The Dormers, 23 Upper Drive, East Preston

Planning Application EP/96/20/HH

Below are our objections and comments relating to planning application EP/96/20/HH.

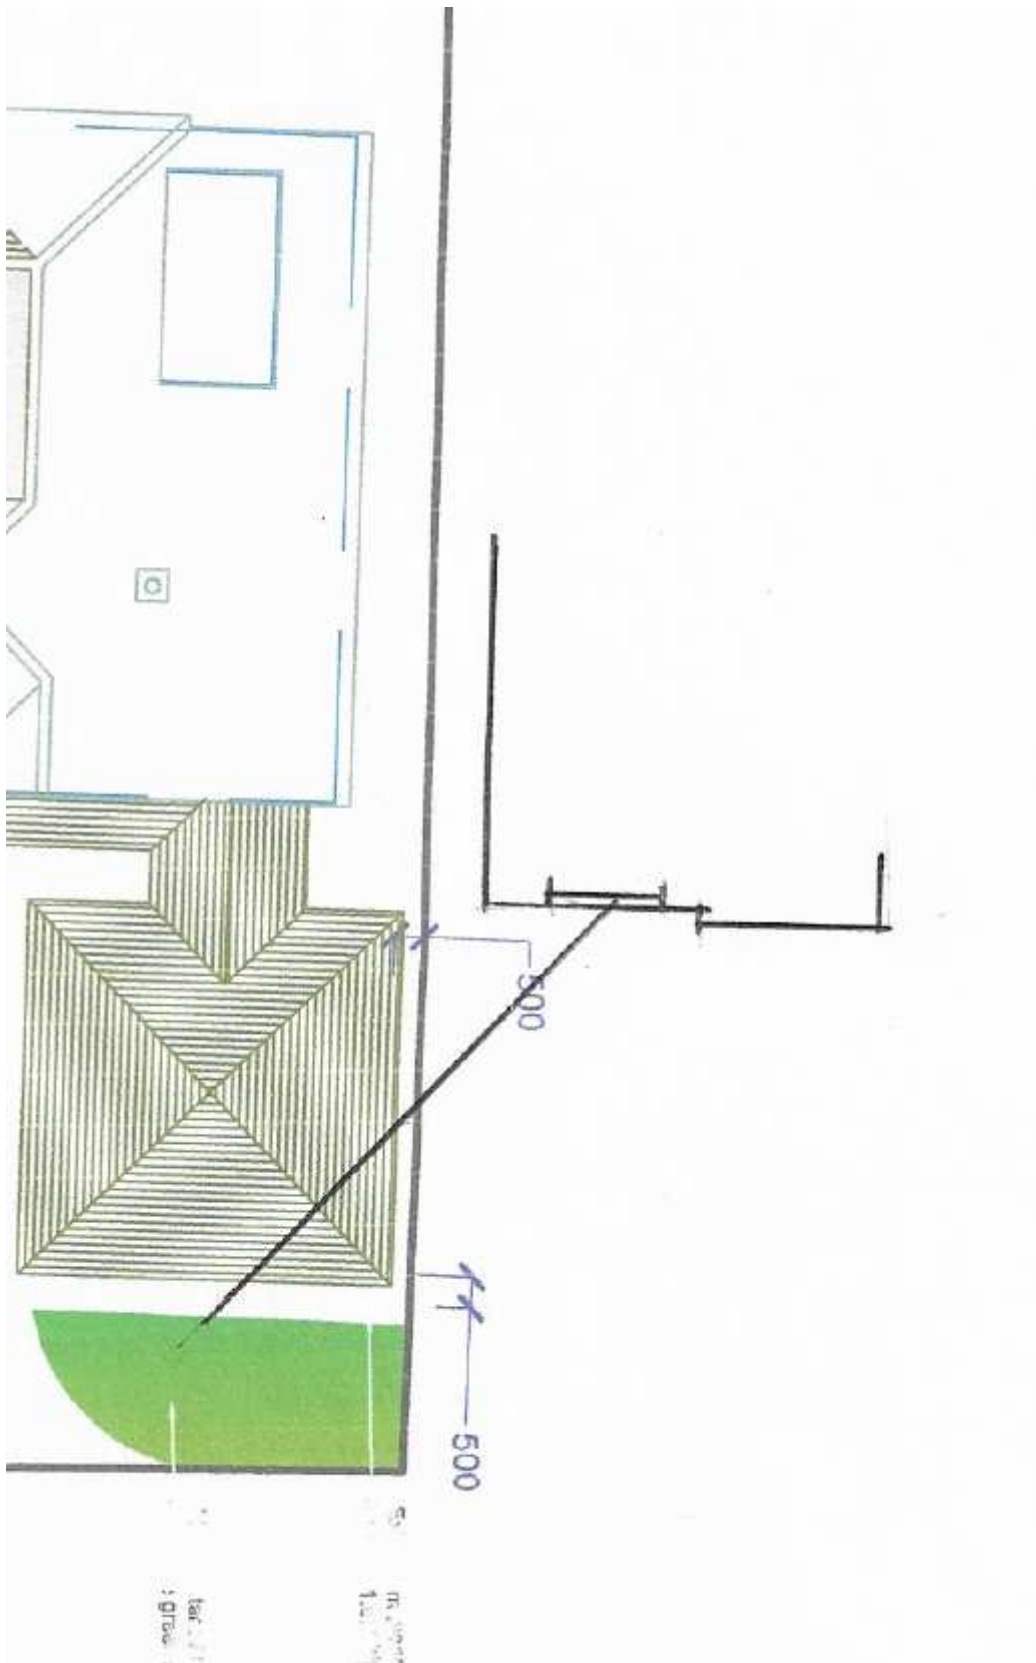
The proposed garage will reduce the level of daylight to our ground floor room which is nearest to number 23.

The proposed garage will cause overshadowing of our front garden, and the front and side of our house.

5. The design does not meet the 45 degree rule.

The impact of overshadowing can often be avoided through the following design measures; in detached houses, by keeping both single and two-storey extensions within a 45-degree line taken from the edge of the nearest ground and first floor windows of habitable rooms in the neighbouring property. (Page 118 – whilst this part of the Guide refers to rear extensions I understand that this rule is in general use and is not restricted to rear extensions).

45 degrees is exceeded even when taken from the centre of the nearest ground floor window as shown by the following diagram and would be significantly exceeded if measured from the edge of the window.
